Whitman County
Carothers Road Solid Waste Facility
New Waste Transfer Building and Site Improvements Project
(Contract No. XEW28)

## ADDENDUM NO. 2

FIGURE G9.2: Redi-Rock<sup>™</sup> Gravity Wall Standard Gravity Blocks up to 18.2 Feet Exposed Height Station 0+00 to 0+70

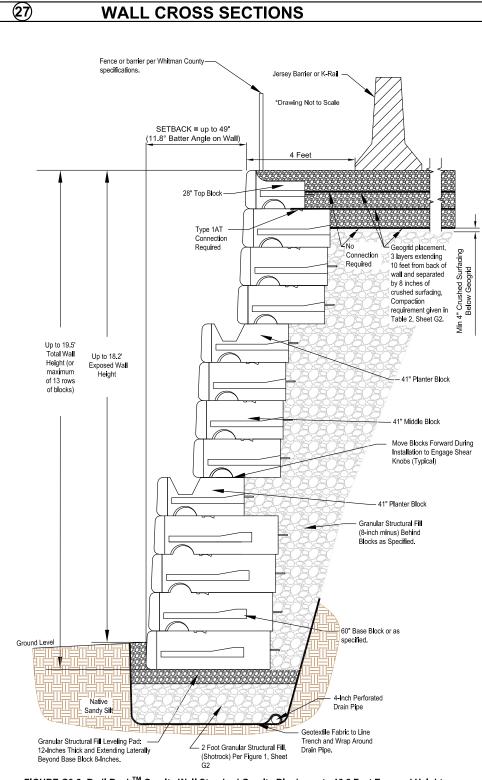
**Attachment A - Strata's Geotechnical Drawing Sheets, Sheet G8:** REPLACE Detail 27 with the attached which shows a maximum exposed wall height of 18.2 feet.

- All wall backfill must be placed as granular structural fill. Wall foundation subgrade preparations and structural fill placement must be observed by STRATA.
   Where the wall is 11 rows or more high (approximately Station 0+00 to 0+70) geogrid (Tensar<sup>TM</sup> BX1200 or biaxial equivalent) is required as shown to extend behind the wall for 10 ft, covered in 8-inches of crushed surfacing (Table 1, Sheet G2)
- 3. Drawing not to Scale.
